Review of Consultant reports for proposed North Totten Inlet Mussel Farm

Prepared by Jack Rensel, Ph.D. Rensel Associates Aquatic Sciences. 03 December 2008

AN ASSESSMENT OF POTENTIAL WATER COLUMN IMPACTS OF MUSSEL RAFT CULTURE IN TOTTEN INLET by NewFields Northwest

Review of ***Supplemental study of dissolved nutrients and particulate organic matter in the waters near the proposed mussel farm in North Totten Inlet, Washington State, USA (undated)*** by Kenneth M. Brooks

Figure 2. Near-bottom dissolved oxygen levels (mg/L) for South Puget Sound in September. Values have not been corrected with laboratory Winkler results.

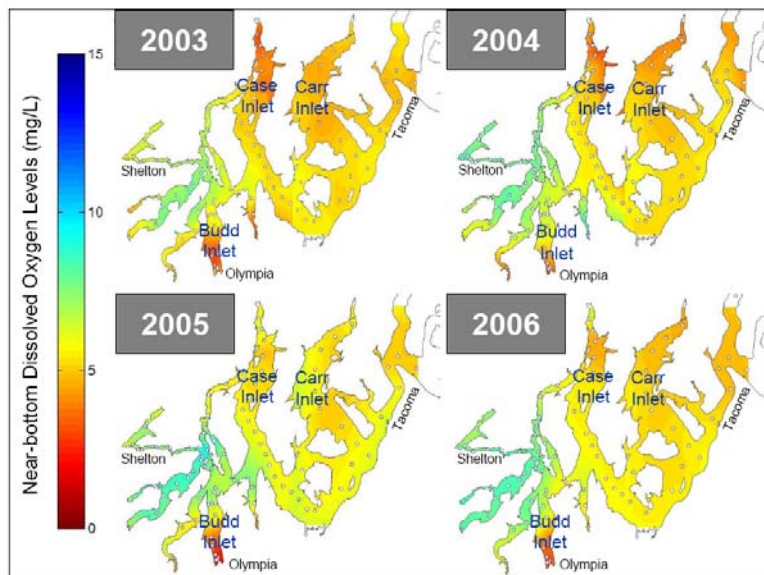
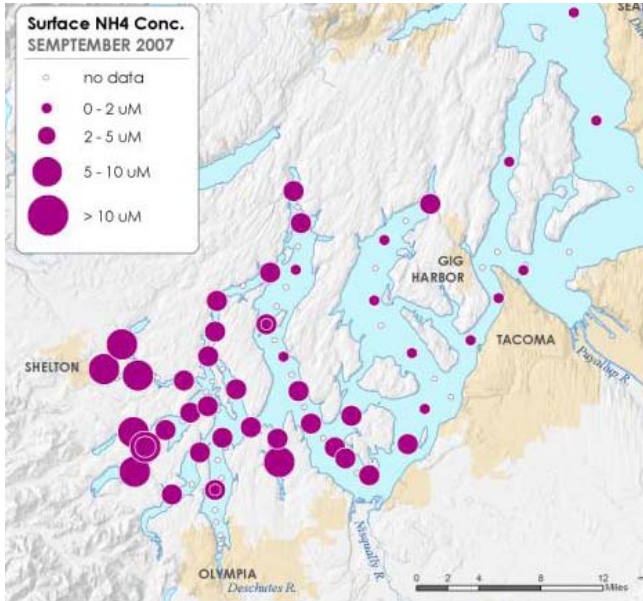
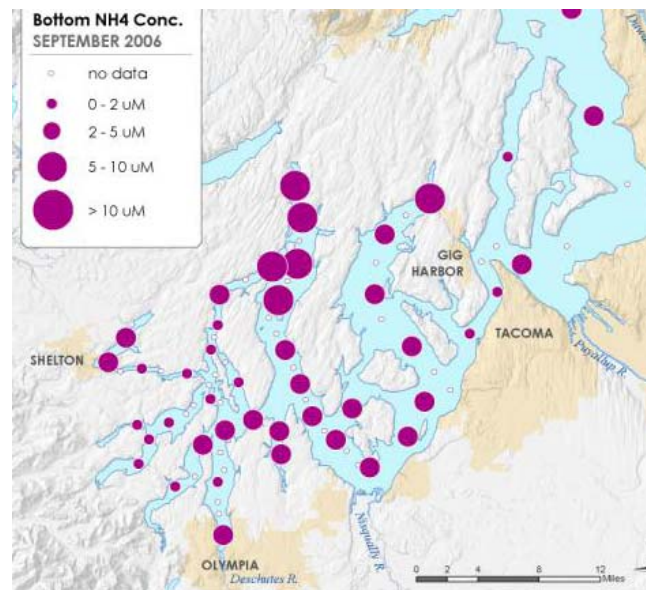
A new interim data report by the Department of Ecology is available that focuses on South Puget Sound (SPS) water quality. The striking graphic to the right shows some of the results and makes it clear that Totten Inlet and in particular Northern Totten Inlet has the best conditions of all of South Puget Sound in terms of near bottom dissolved oxygen. I recommend that the final NewFields report at least briefly reference this report and possibly ask to use this figure.

See http://www.ecy.wa.gov/puget_sound/docs/SPSDOS_datareport_Jun08.pdf Contact Mindy Roberts, the professional engineer for Ecology and lead author for more details and permission to use the figure. mrob461@ecy.wa.gov There are also other highly pertinent findings regarding nitrogen and near bottom ammonia that show that NTI is very different than the southern portions of Totten Inlet as well as more circulation information not previously available, but the DO results in particular are timely to address the near bottom DO conditions in Totten Inlet discussed above. You will need to obtain the QAPP to see what they mean by near bottom, as it doesn't seem to be defined in the data report but it is a discrete near bottom measurement, not just the deepest of the normal CTD casts.

Part of figures 79 and 89 from the new Ecology data report showing surface and near bottom ammonium concentrations for the worst case timing of the annual cycle. Note how bottom ammonia concentrations are very low in all of Totten Inlet compared to all the other inlets.
